Planning Portal Reference: PP-3472959
Lanpro Project Number: 4977/P

Application for Approval of Details Reserved by Condition Pursuant to Planning Permission Reference: 192928. Construction of the South Wokingham Distributor Road ('SWDR') at Land South of Wokingham, East of Finchampstead Road and West of Waterloo Road, Wokingham

Further to my email of 13 May, below are the issues that need to be addressed before conditions details can be approved.

Condition 5 levels (213441)

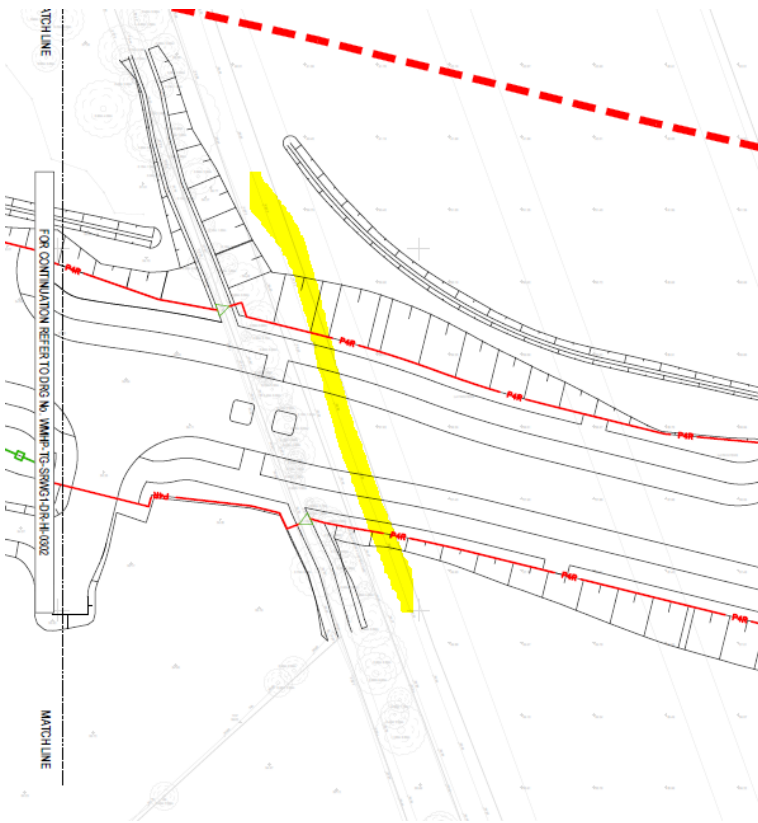
Please provide chainage drawings and longitudinal sections, as provided at the original application stage, showing existing, approved and proposed levels to allow comparison. I am aware that the consortium have raised concerns about the level of the road being increased and need to understand the scope of the issue.

and on WMHP-TG-SRWG1-DR-HI-301:

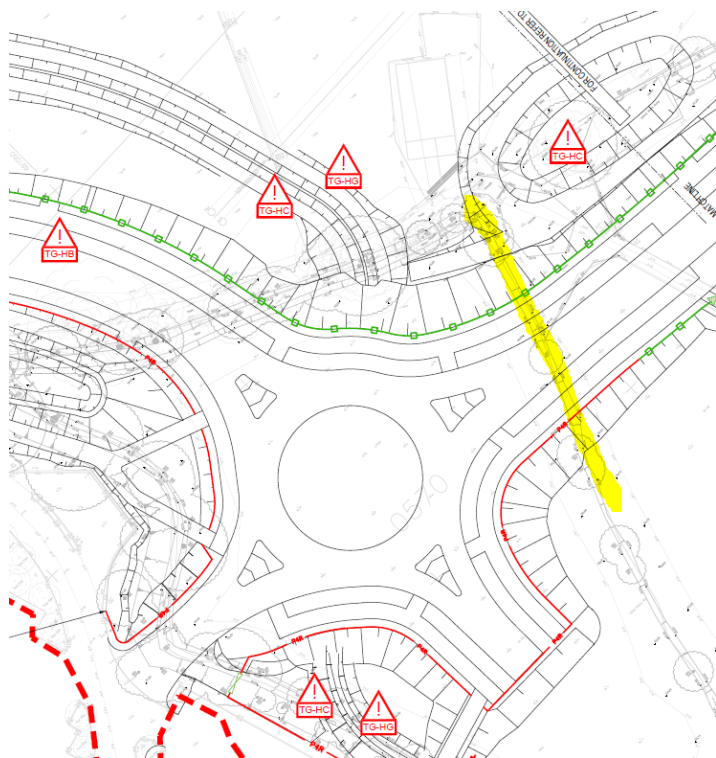
Additional mammal tunnels are required in these two locations, with reference to the fencing plans, on WMHP-TG-SRWG1-DR-HI-0303 (highlighted yellow):

Condition 11 AMS (213554)

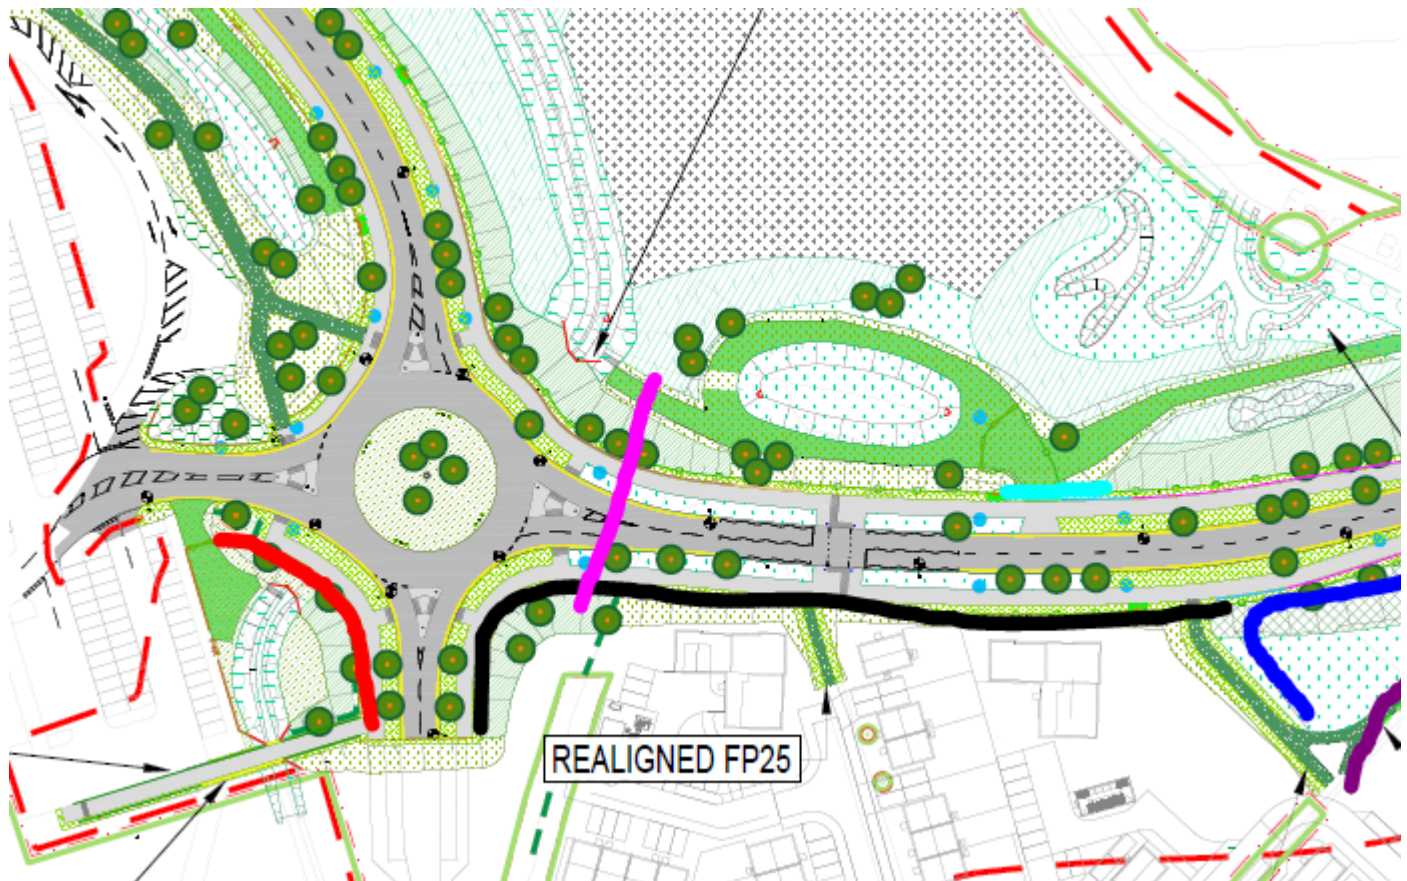
A revised AIA has been submitted but not an AMS which will need to be submitted to comply with this condition.
